AGENDA

NORTHERN BEACHES LOCAL PLANNING PANEL

WEDNESDAY 2 MARCH 2022

ITEM 4.1	DA2021/2034 - 30 FAIRLIGHT STREET, FAIRLIGHT - DEMOLITION WORKS AND CONSTRUCTION OF A RESIDENTIAL FLAT BUILDING
AUTHORISING MANAGER	Rodney Piggott
TRIM FILE REF	2022/104964
ATTACHMENTS	1 Assessment Report 2 Site Plan and Elevations 3 Clause 4.6 4 Design and Sustainability Advisory Panel Report

4.1.2 Height of Buildings (Incorporating Wall Height, Number of Storeys & Roof Height)

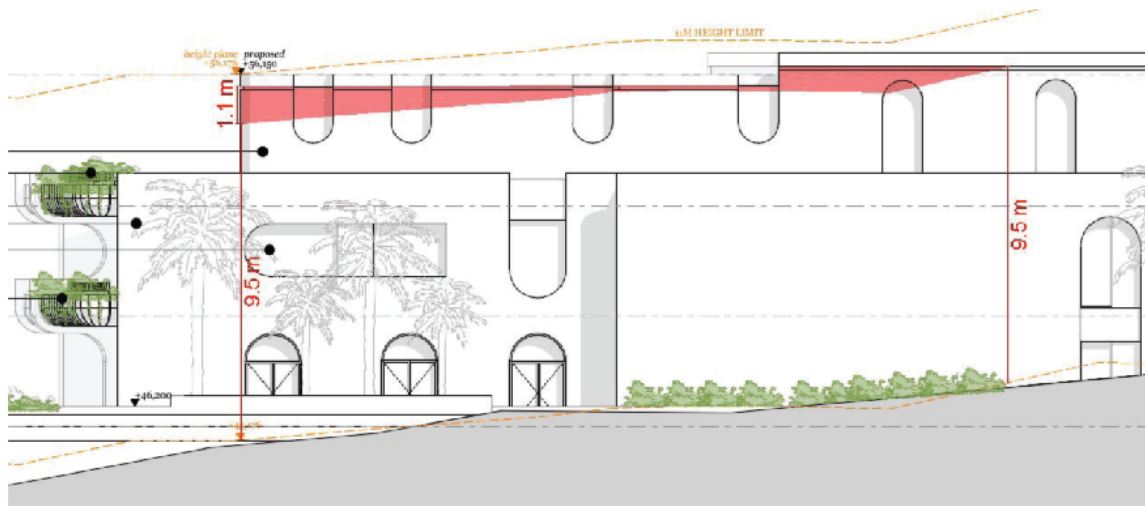
Clause 4.1.2.1 permits a maximum wall height of 9.5m for the site. The proposed Level 2 exceeds the control up to a maximum height of 10.6m at the eastern elevation and 10.3m at the western elevation. The extent of the wall height breaches are indicated on the below plans:

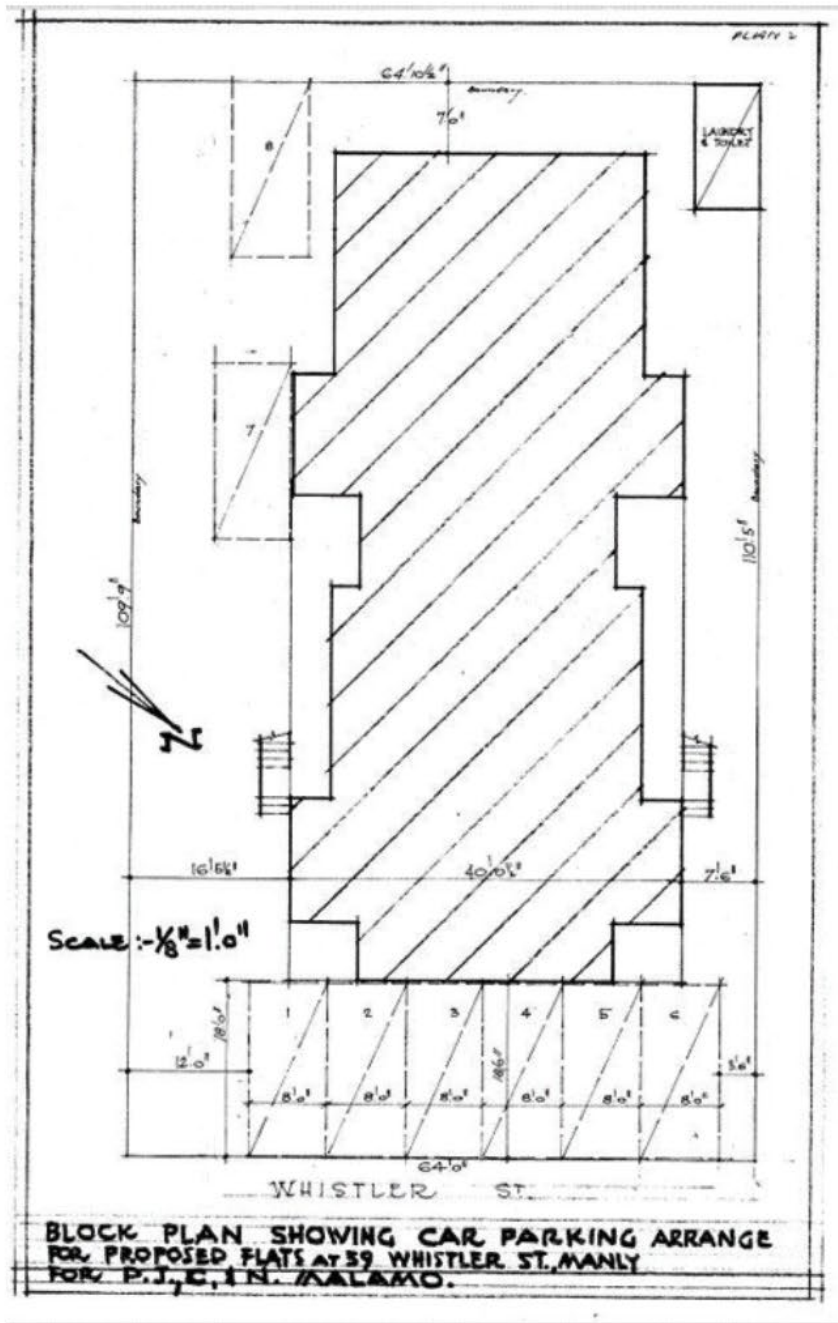
The image below shows what the car parking arrangement for No. 57 Whistler Street should be.

Space No. 7 is not currently in this location on site, instead it sits next to space No. 8, and within the ROW. While this situation seems to have existed for an extended period of time, it does not appear to be a formal arrangement and so the request to maintain the space at the rear of the ROW does not appear to be achievable unless the terms of the ROW are changed.

No. 57 Whistler Street should not be relying on a space within the ROW to achieve its requirements. The requests to have this space need to be resolved between the two parties and the terms of the ROW adjusted if an agreement is reached.

Figure 1 - Applicant's diagram of height of boatshed relative to highest astronomical tide. Left showing previous (now demolished) boatshed, right showing proposed.

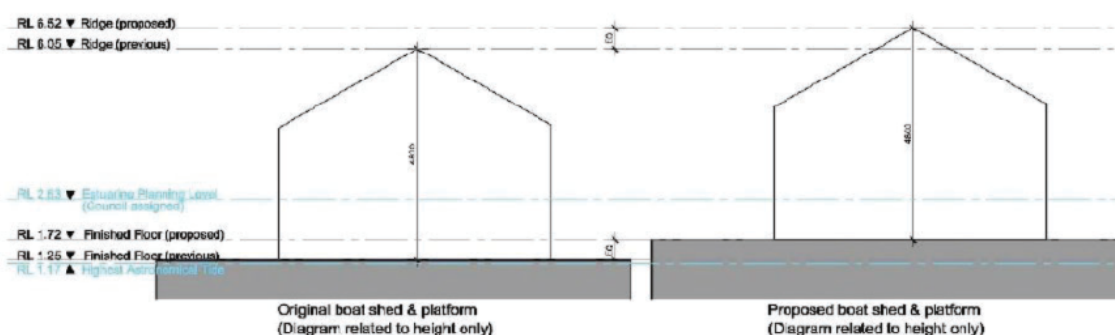
Development standard:	Height of buildings
Requirement:	4m
Proposed:	5.35m
Percentage variation to requirement:	34%

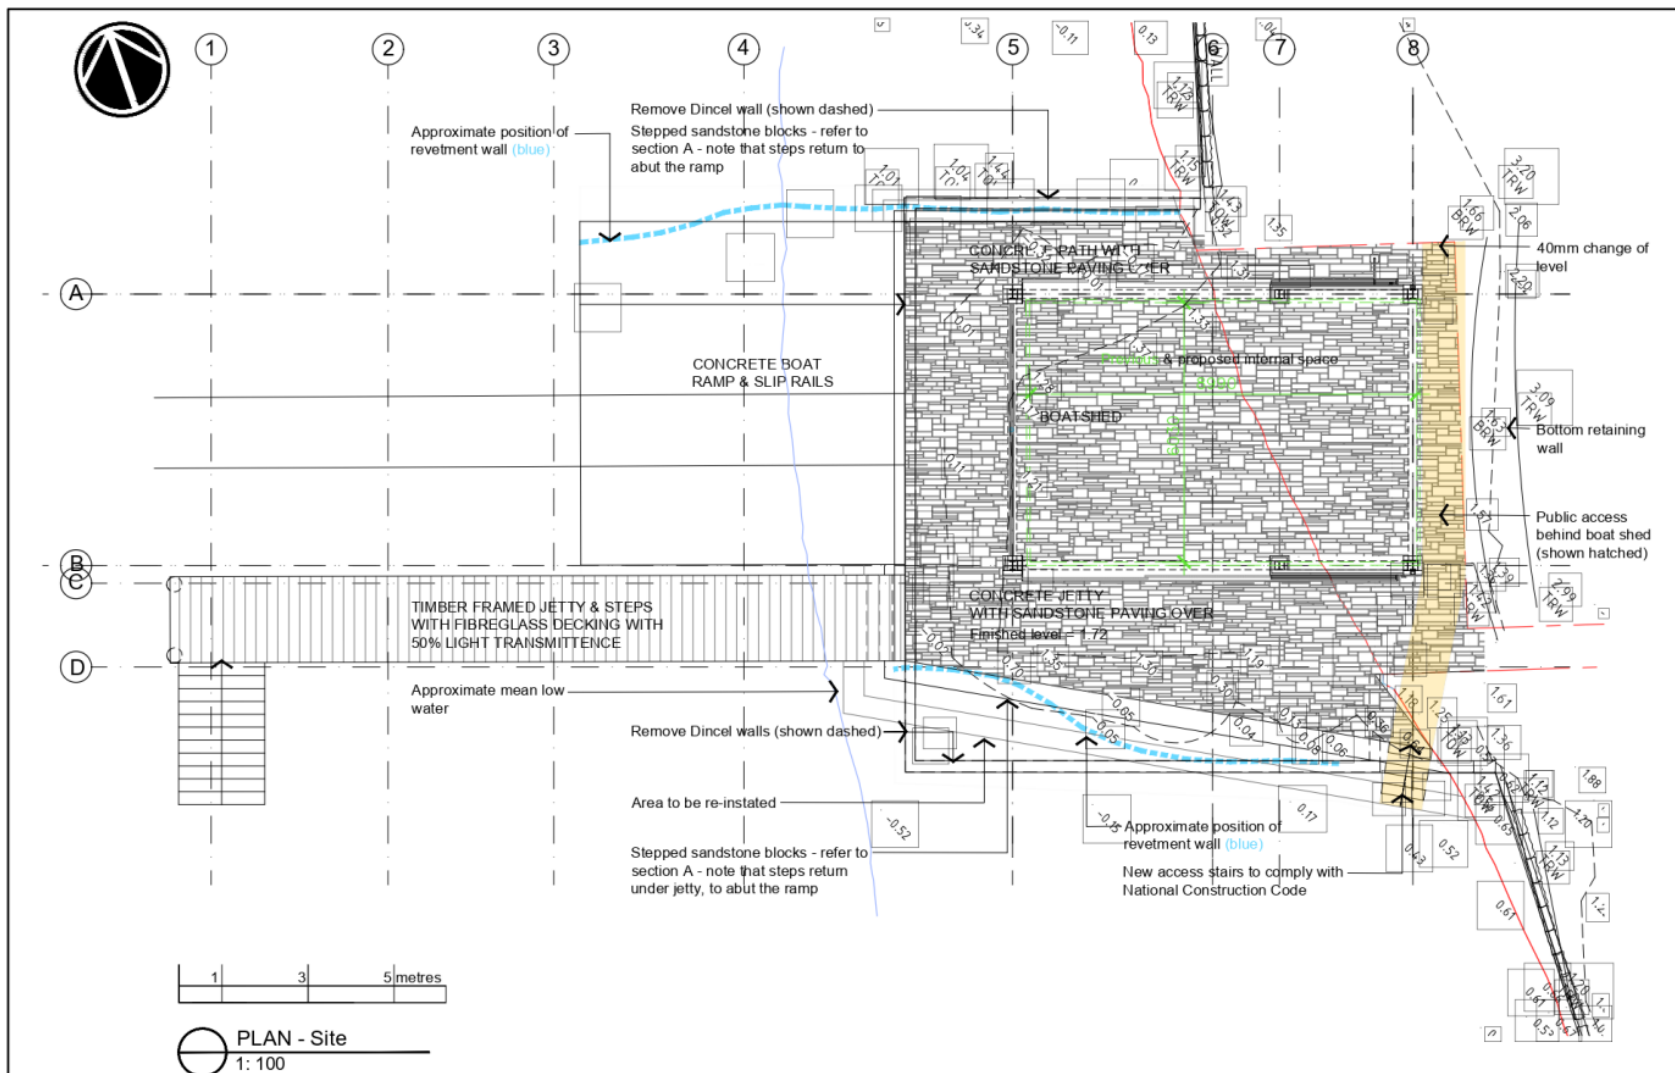
Public access along the foreshore is to be provided and maintained as shown in the updated Plan Drawings DA-001 received Aug 2021.

Gates, locks and signage that restrict public access along the foreshore and behind the boatshed are not permitted.

2.7 Demolition requires development consent

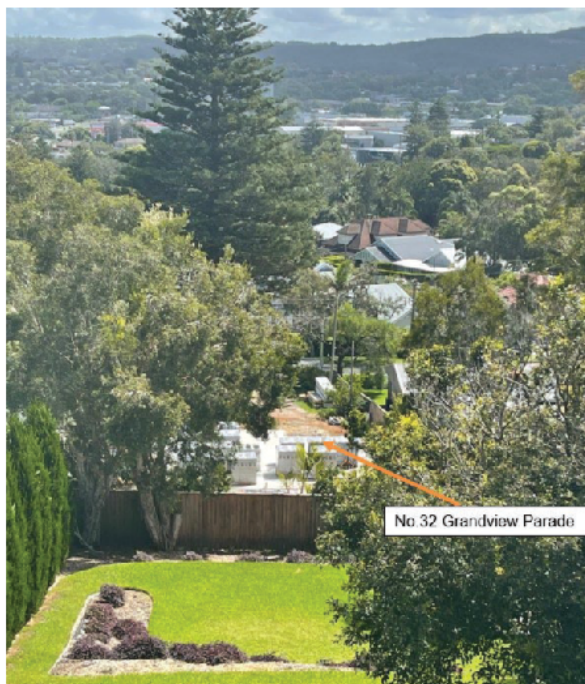
In response to the notification of this application, one (1) submission was received from the adjoining neighbour to the east (No.25 Hillcrest Avenue) in relation to view loss. This submission raised concern regarding views to *"properties on Orana Road through to Barrenjoey Road and beyond into Mona Vale"* and *"district views"*. The objector provided a photo of this view of concern as demonstrated in Photo 1 below:

Concern was also raised with regards to proposed landscaping within the rear garden and impacts to district views. The proposed modification does not seek to alter the approved landscape plan, and the existing garden bed at the rear of the site is proposed to be retained. No new substantial trees are proposed as part of this application. Furthermore, the objectives of clause C1.3 View Sharing of P21 DCP specifies that canopy trees take priority over views.
